SEWAGE DISPOSAL SYSTEM
DEPARTMENT OF HEALTH AND MENTAL HYGIENE

A REPAIR

ADDRESS Route 144, Ellicott City, Maryland 21043 PHONE 465-6646 Mag 10

SITE INSPECTION SHEET

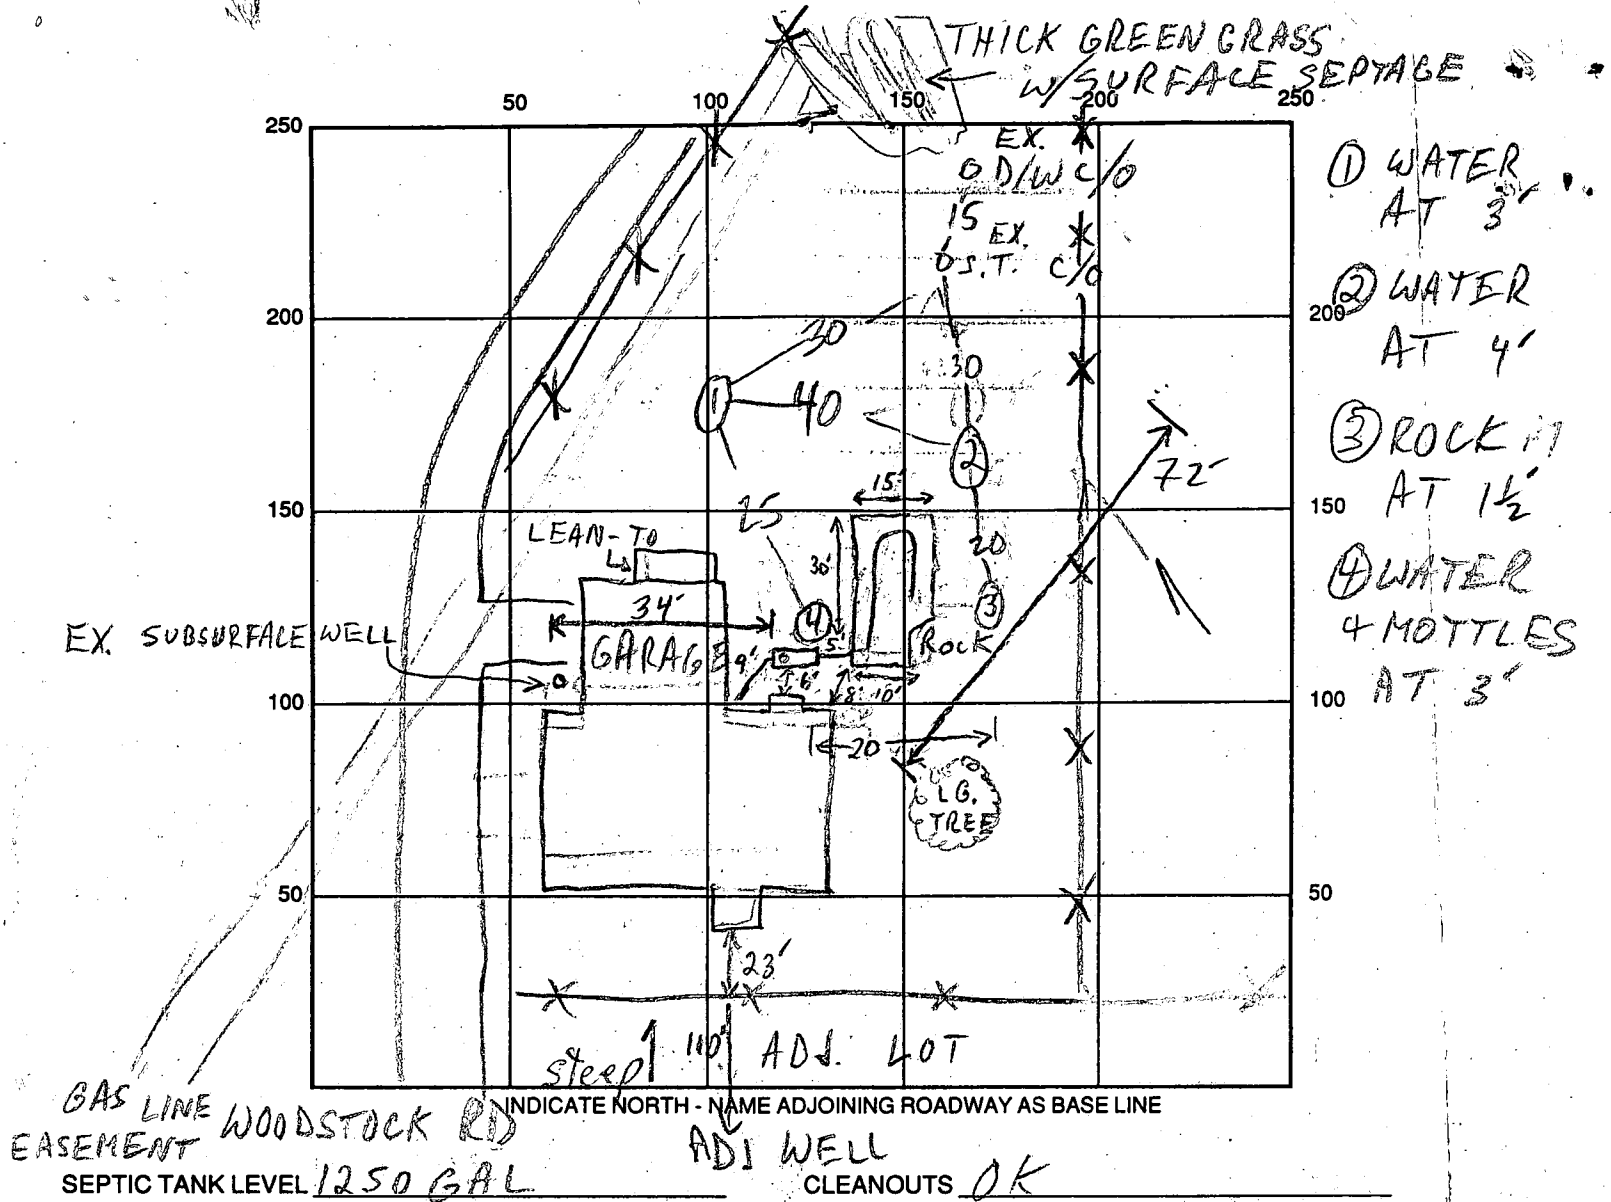
15' x 25' LEACHING BED; INLET 1' BOT 2 1/2'; TOPSEAM TANK

4/91 - LEACHING BED, FAILED, DISCONNECTED (H₂O TABLE);

FINAL DISPOSITION: DUAL HOLDING TANK SYSTEM (OLD S.T. & NEW S.T.)

LOCATION DIAGRAM

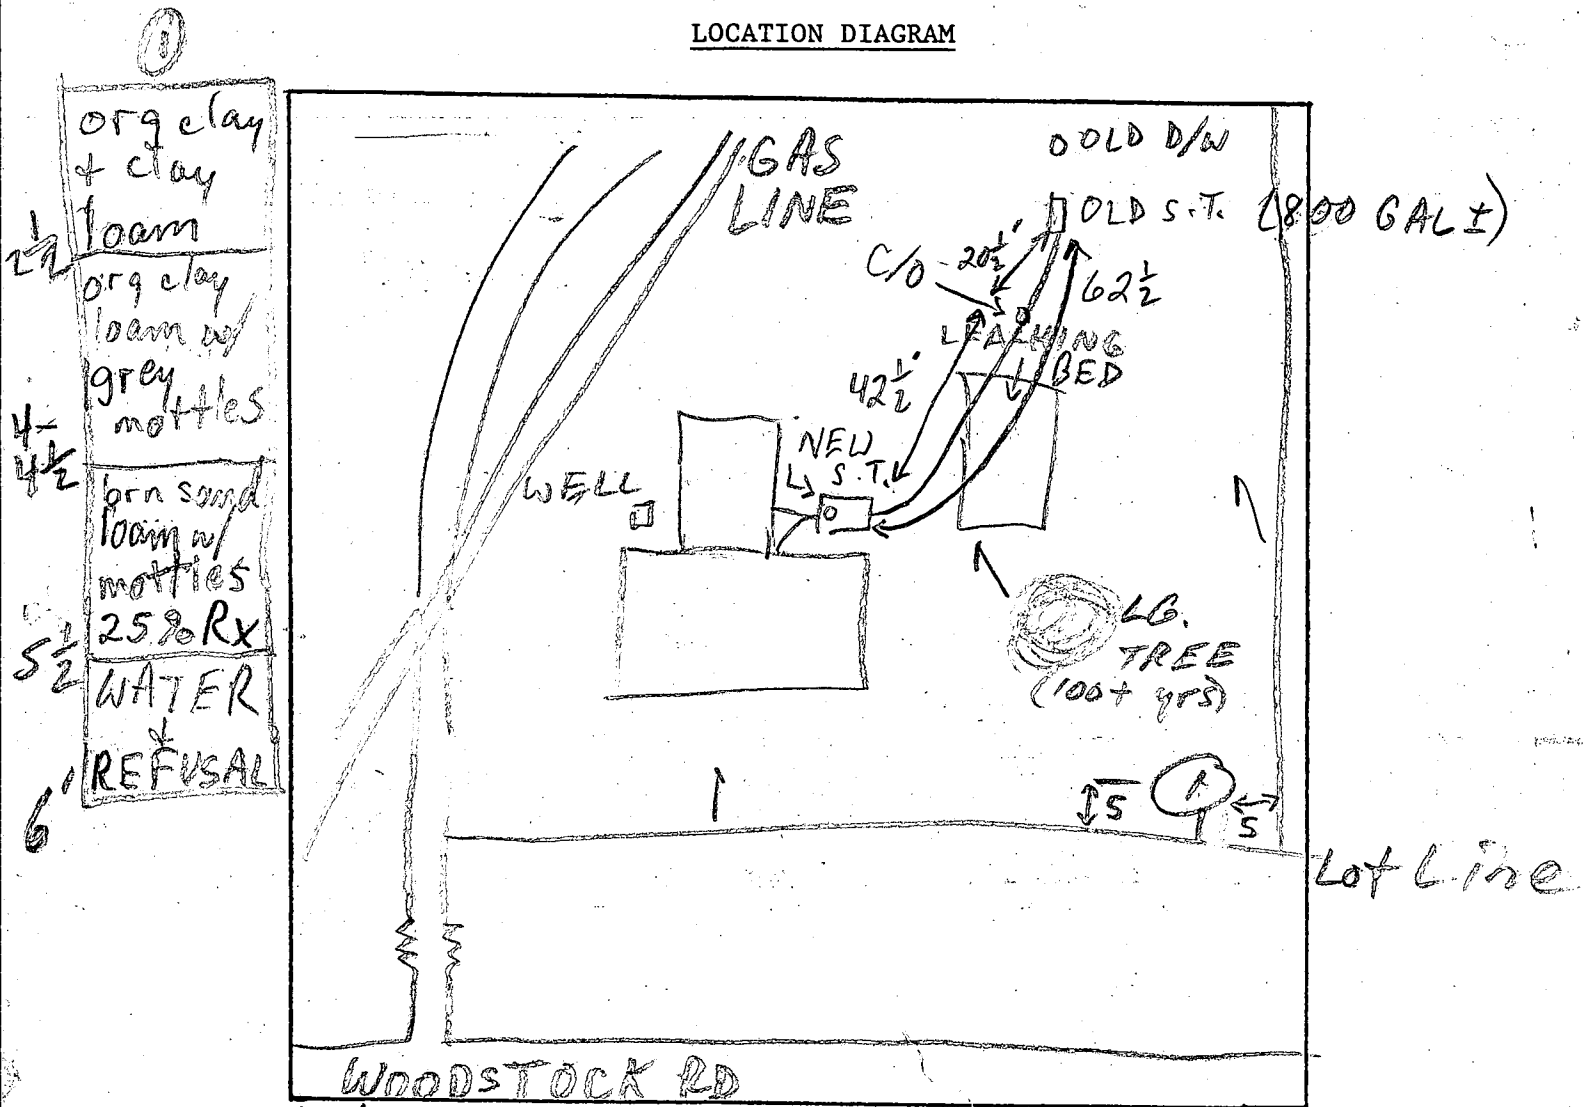
- ① WATER AT 3'
- ② WATER AT 4'
- ③ ROCK AT 1 1/2'
- ④ WATER 4 MOTTLES AT 3'

COMMENTS: 4/19/91 S.T. & LEACHING BED FILLED W/ GROUND WATER; ONLY OPTION REMAINING IS HOLDING TANK MR
4/23/91 #1 OLD S.T. PUMPED, RAINWATER REFILLED IT; D/W STILL CONN. TO A WASH. MACH; TOLD THEM TO CONN. TO MAIN SYSTEM MR
4/23/91 #2 OLD S.T. PUMPED 6" H₂O IN TANK MR
4/24/91 CONTRACTOR & OWNER CHECKED NEXT DAY - WATER LEVEL UNCHANGED OVER →
CONCLUSION - TANK DOES NOT LEAK - OK TO KEEP IN SERVICE AS HOLDING TANK G.W.

WATER LEVEL NEXT TO OLD S.T. 2' B.G.; WATER LEVEL
IN TANK ~~2~~ 3½' B.G. - OLD S.T. OK; SCH 40 IN
BETWEEN 2 SEPTIC TANKS; OUTLET PLUGGED IN OLD S.T.;
ALL OK TO COVER; BUT D/W STILL NEEDS SOME
PUMPING & ABANDONMENT MR 4/25/91

4/25/91 COLLINS INDICATES HE WILL TAR OUTLET
ON OLD S.T. MR

5/16/91 COLLINS TARED OLD S.T. OUTLET, COMPLETED
CONN GREY WATER LINE, & COLLAPSED
D/W; ALL WORK OK MR
